RE: **60 BAY AVE HIGHLANDS, LLC**
Response Letter (HLPB2024-02)
Block 42, Lot 1;
60 Bay Avenue
Borough of Highlands, Monmouth County, New Jersey

We are submitting this letter on behalf of the Owner/Applicant in response to Roberts Engineering Group LLC's Review Letter dated May 21, 2025. Each comment and response are numbered in accordance with the aforementioned review memo. *Italicized text is taken from the review memo for your ease of reference;* non-italicized text represents our responses.

Review Letter, dated May 21, 2025

PRELIMINARY & FINAL MAJOR SITE PLAN FOR PROPOSED MULTI-FAMILY RESIDENCE

SHEET TITLE:
CIRCULATION PLAN

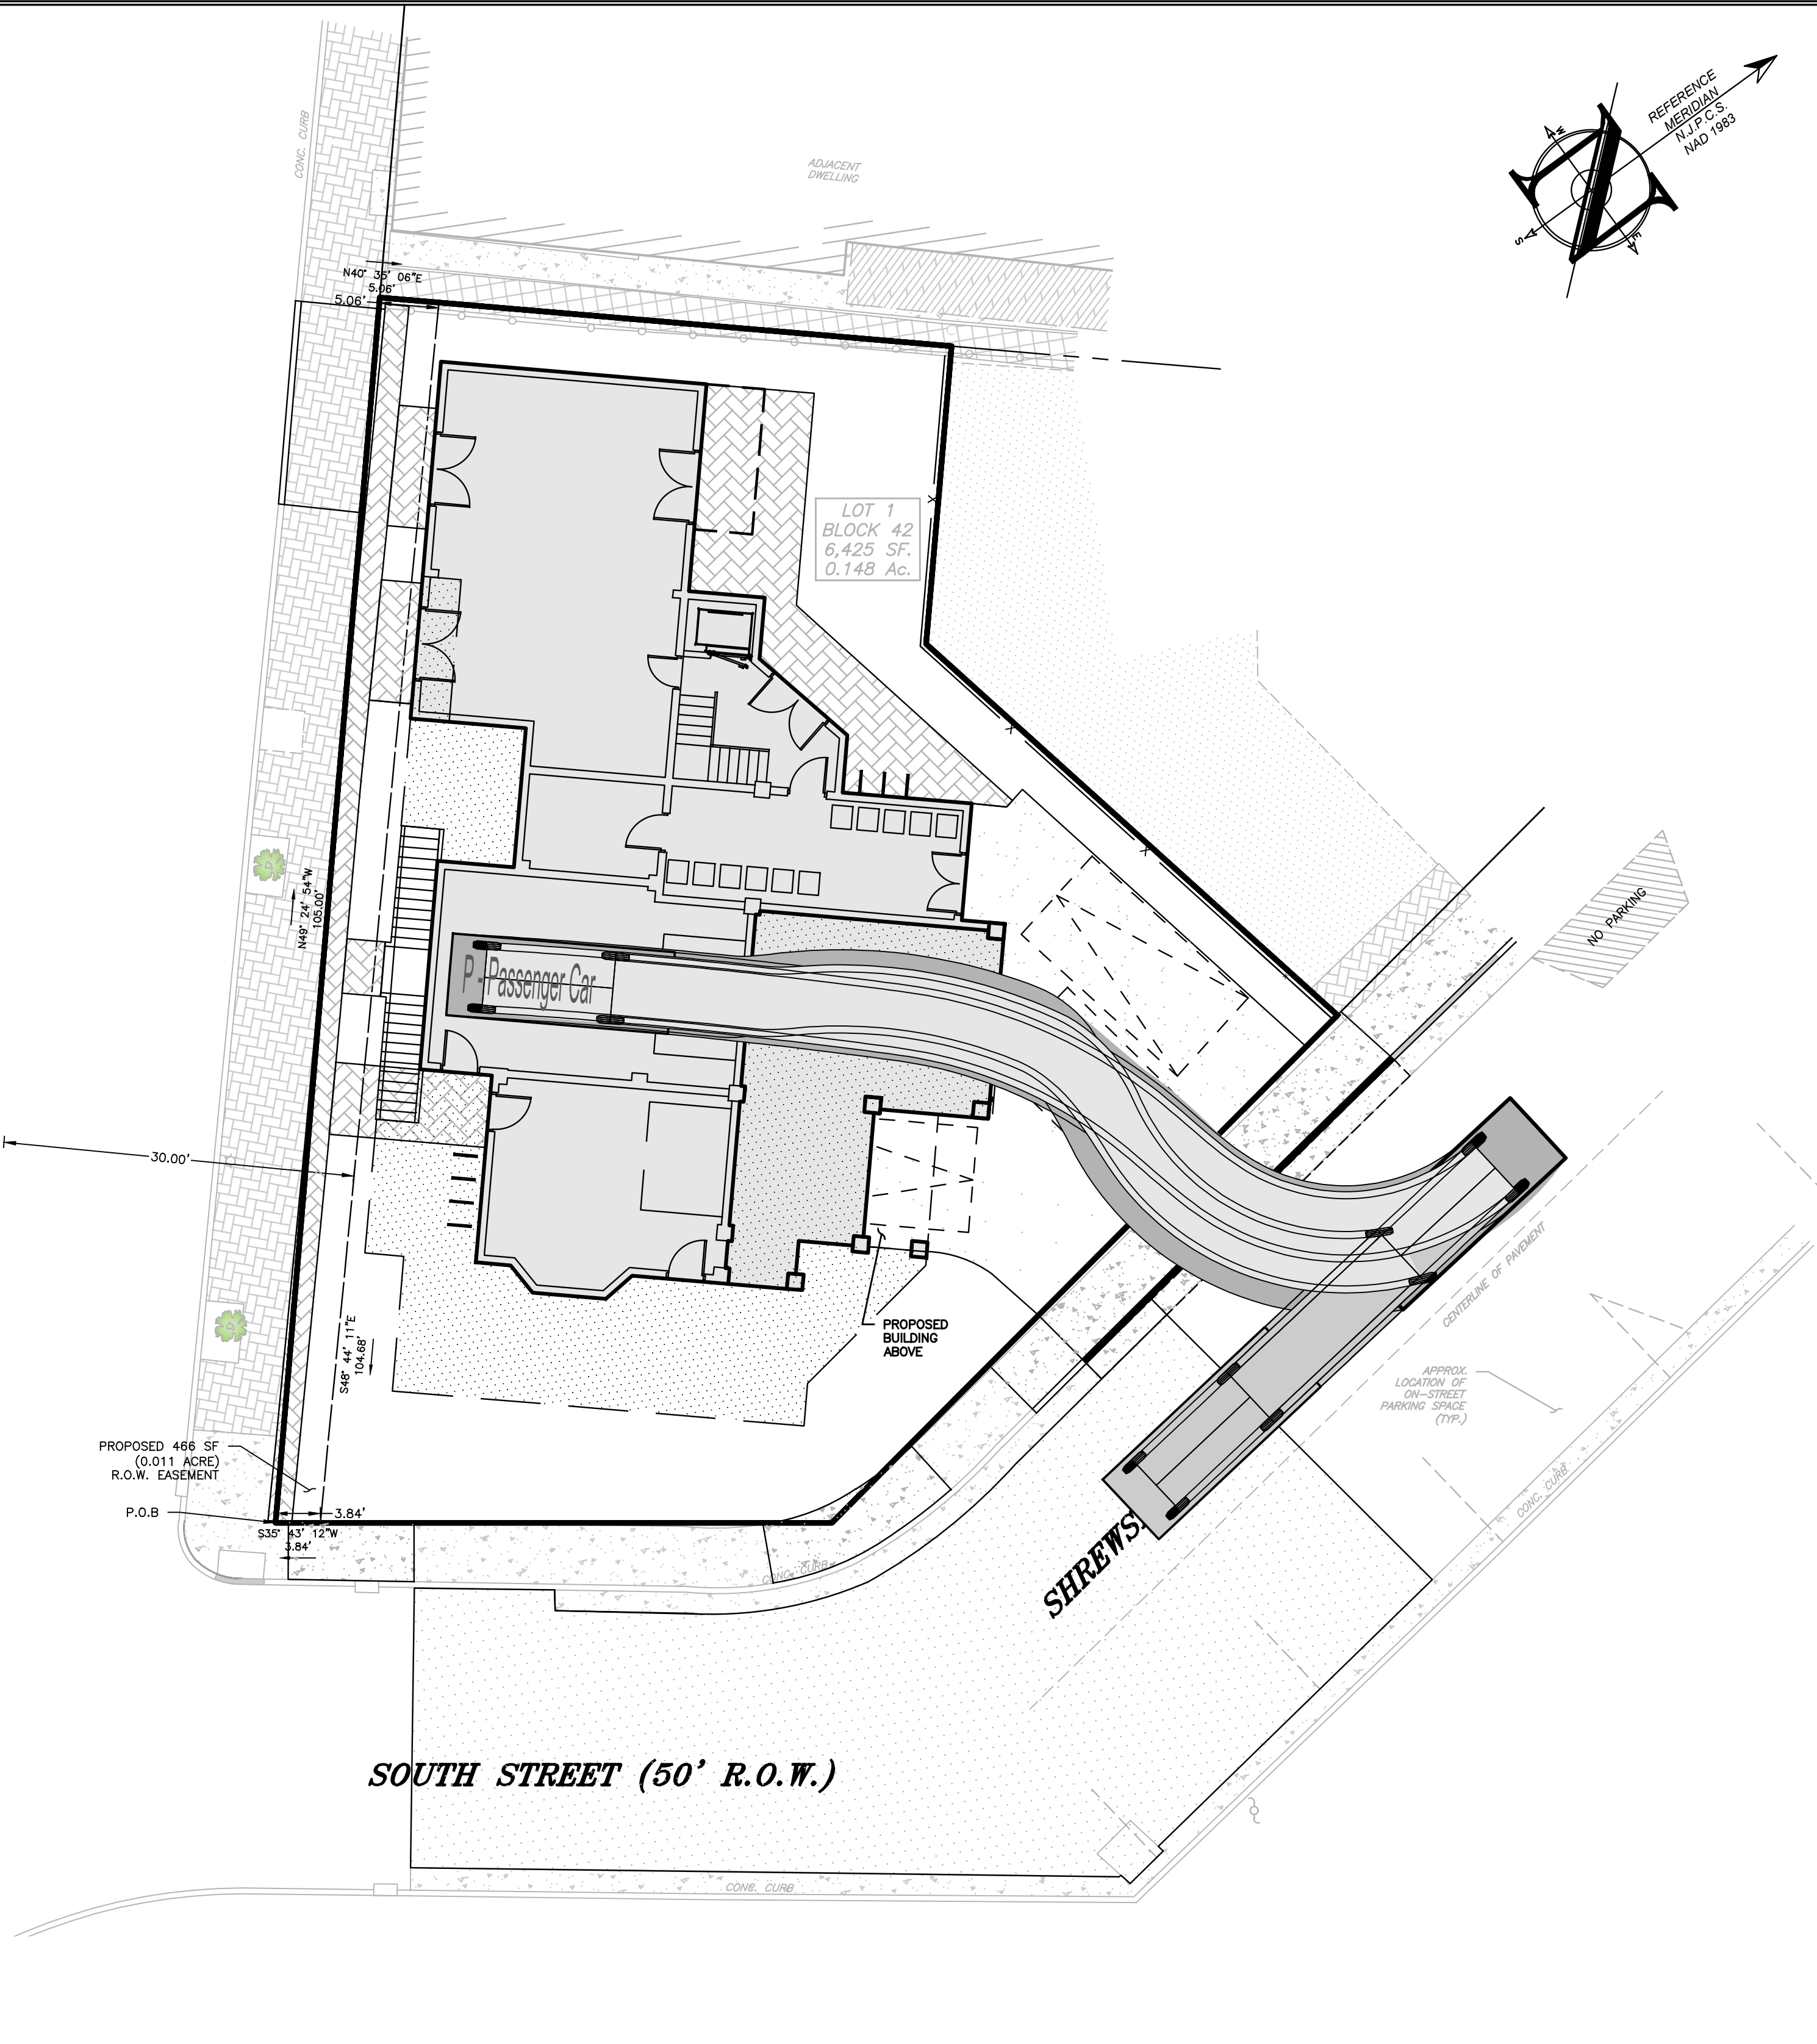
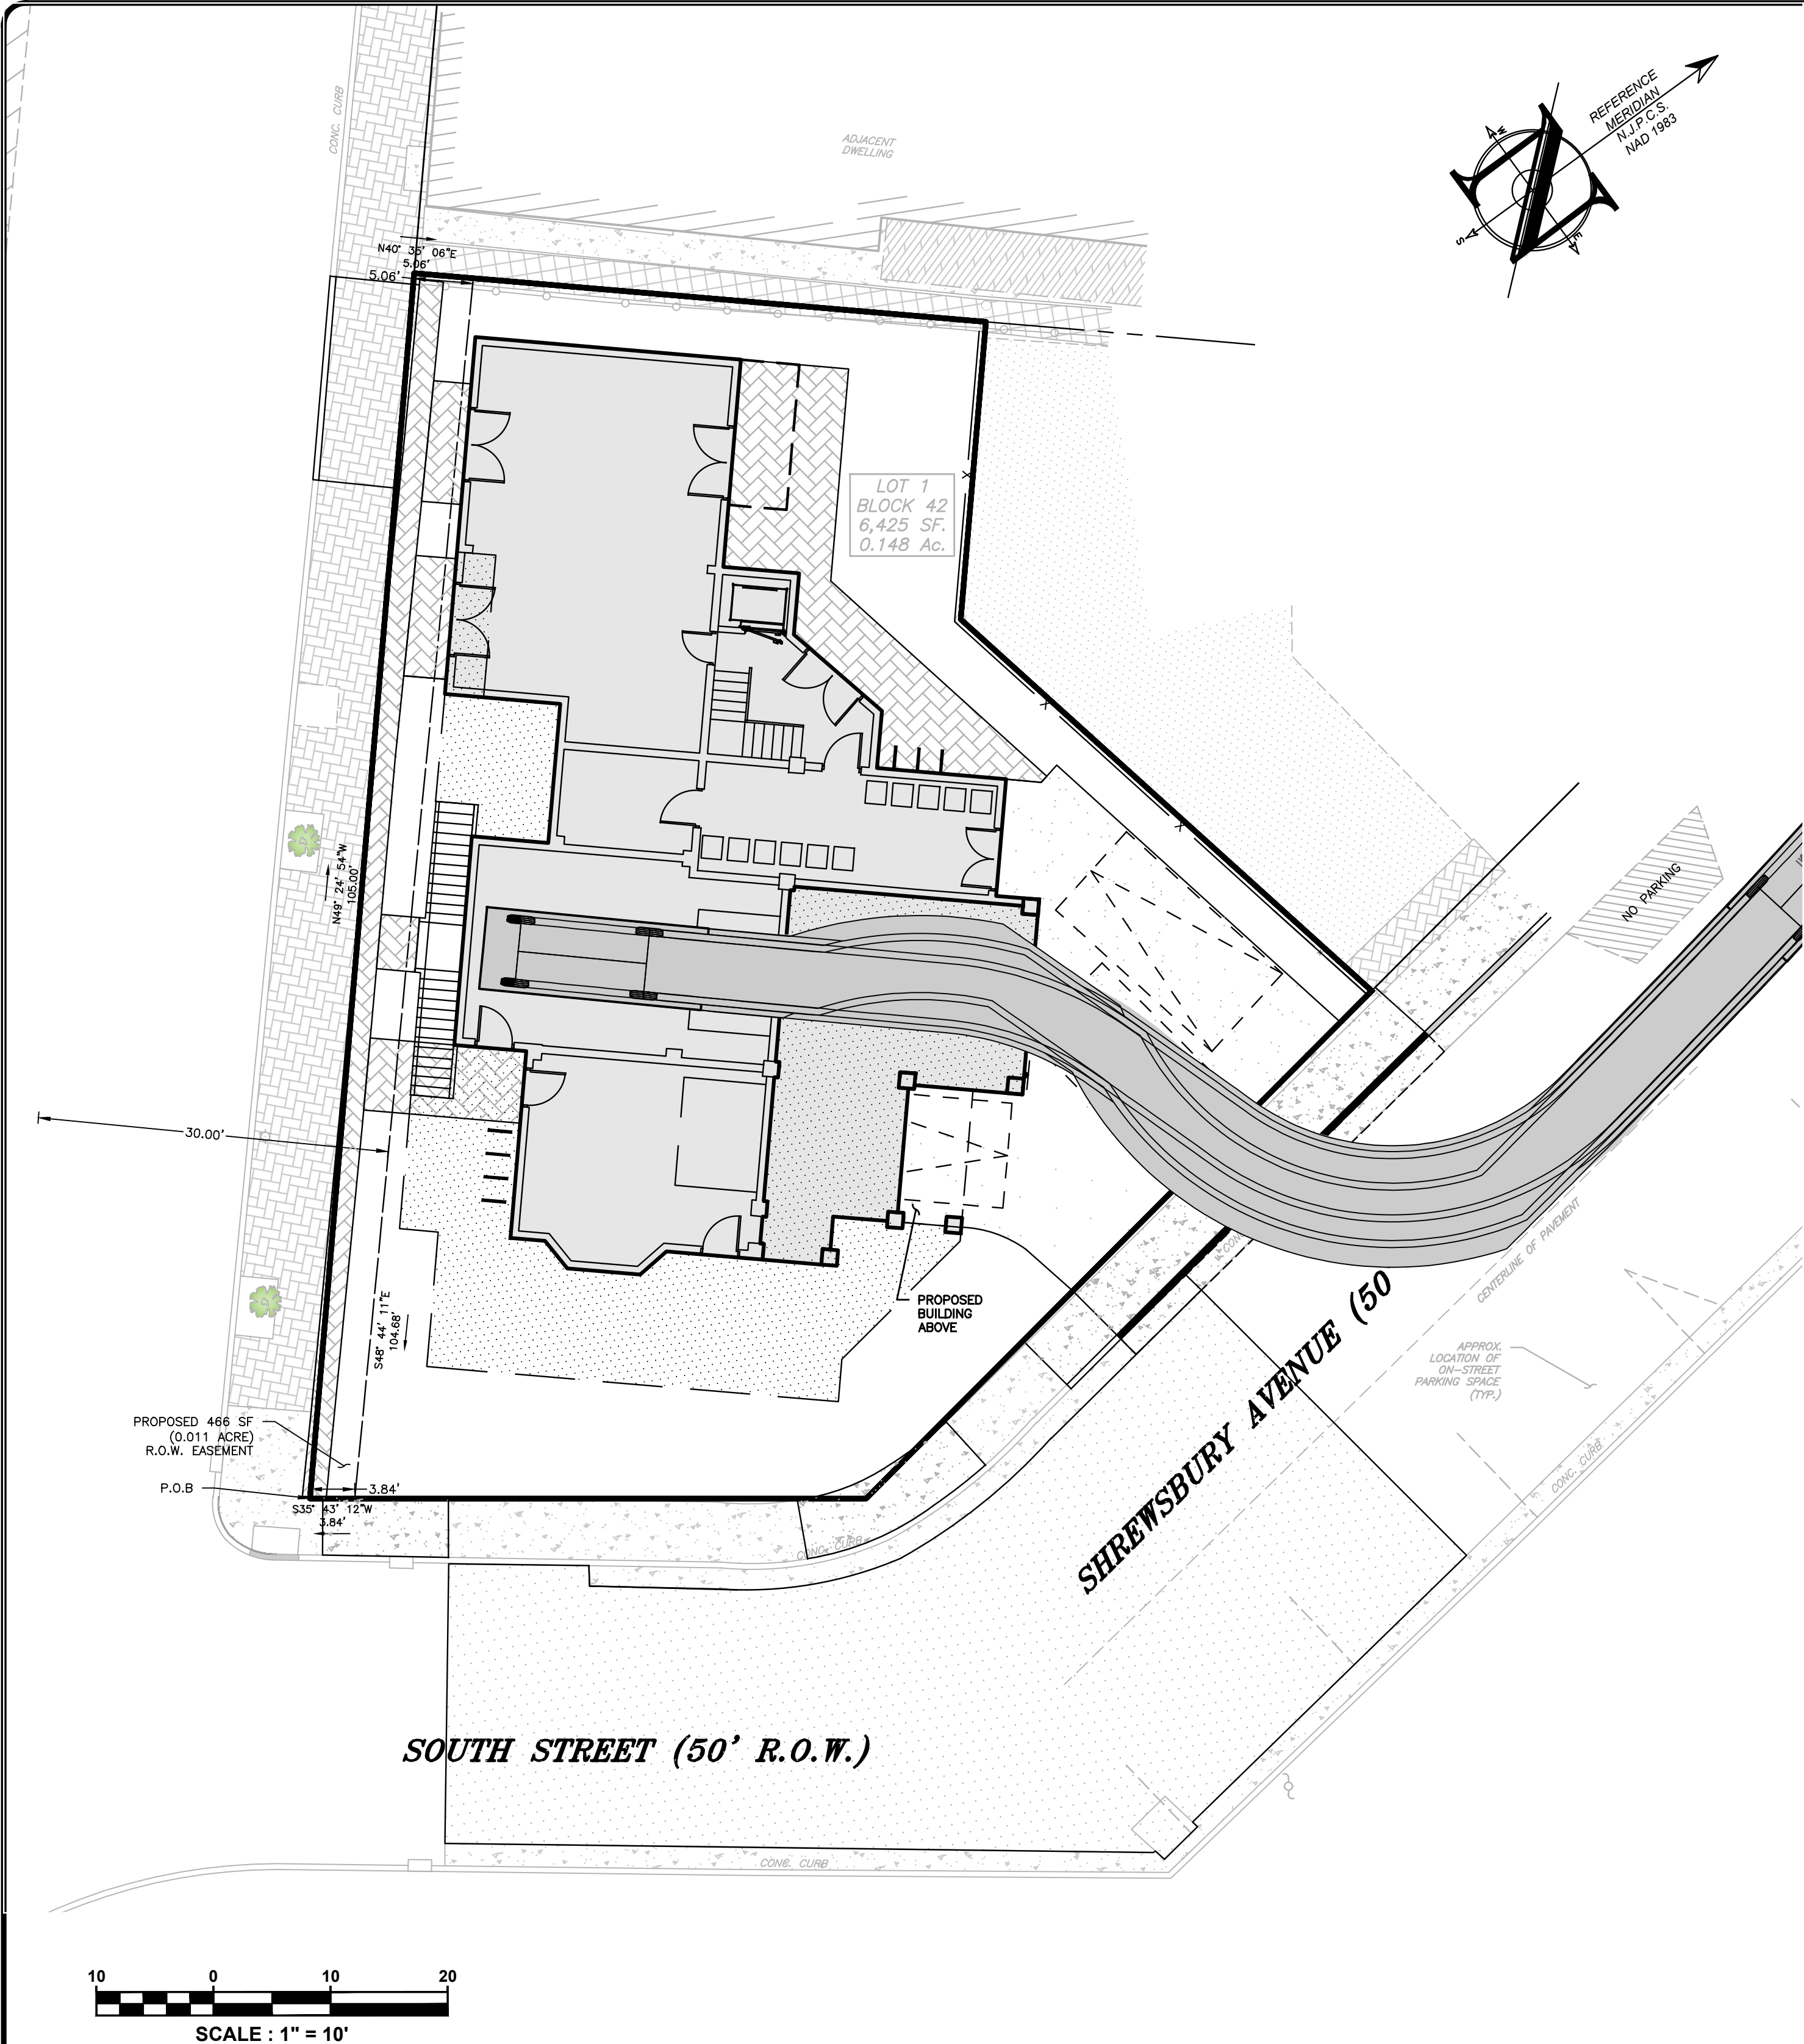
10. *The Applicant has provided six (6) circulation plans indicating the existing parking spaces along Shrewsbury Avenue. The circulation plans demonstrate vehicles maneuvering Shrewsbury Avenue by accessing the driveways and garages. These maneuvers are of great concern and appear so difficult as to be questionable.*

We question the size and location of the driveways. The turning templates provided for maneuvers in and out of the garages require turns, starts and stops. Some of the turning templates indicate that vehicles must drive into opposing traffic to be able to enter the driveways and garages.

In addition, garages on Shrewsbury Avenue appear to show that cars cannot enter and exit without sideswiping the door opening. When a car is parked in the space near the rear property line, the vehicle entering and exiting the garage on to Shrewsbury Avenue seems to sideswipe the parked car. Please explain.

The Applicant is to provide specific testimony and presentation to clearly show how all driveways will be accessed from Shrewsbury Avenue, and how all garages will be entered, without driving into opposing traffic. The applicant must provide details of how these driveways will allow for proper and safe operation for entering and exiting.

The turning movement plans were revised to show pulling in and pulling out of each of the parking areas, while considering the location of parked vehicles. The centerline

of Shrewsbury Avenue was added to the plan and no lane incursions into opposing traffic are proposed.
